**To our customers of
Infinity CentralStation (ICS) VG3 or lower
And Edifier Speaker**

Important Safety Notice

The Edifier speakers (Purchased in or after April 2023) do not generate audio when the ICS is configured to analog mode and the speakers revert to USB mode.

Affected Devices: Infinity Central Station (MS26800) VG3.0 or lower and Edifier speakers (MS34036). See Attachment 1 to identify the affected speaker.

Attachment 1: Identification of New Speaker and Differentiation Between Old and New Speaker

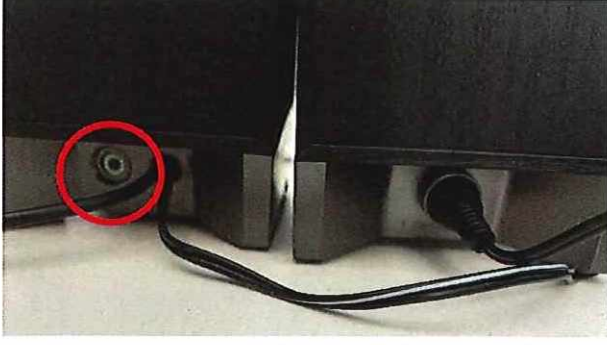
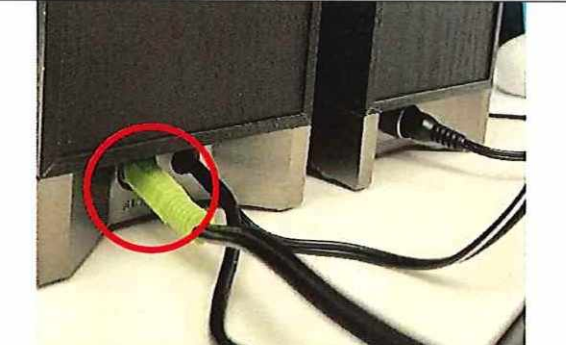
According to our records, you have received at least one affected ICS VG3 or lower (MS26800) manufactured by Draeger Medical Systems, Inc. (European Single Registration Number: US-MF-000020721, UDI: 04049098001878) and have ordered and received the new Edifier speakers (MS34036, UDI: 04048675548027) that may be affected by this issue. The new speakers can be identified by locating a light on the front face and to differentiate between old and new speakers, the old Edifier speaker have a flat façade with no light (see **Attachment 1**).

<p>Note the square bottom, no button, and no light.</p>	<p>Note the angled bottom, button, and red/green light.</p>
	 <p data-bbox="1096 1291 1177 1333">Light</p> <p data-bbox="1234 1354 1331 1396">Button</p>
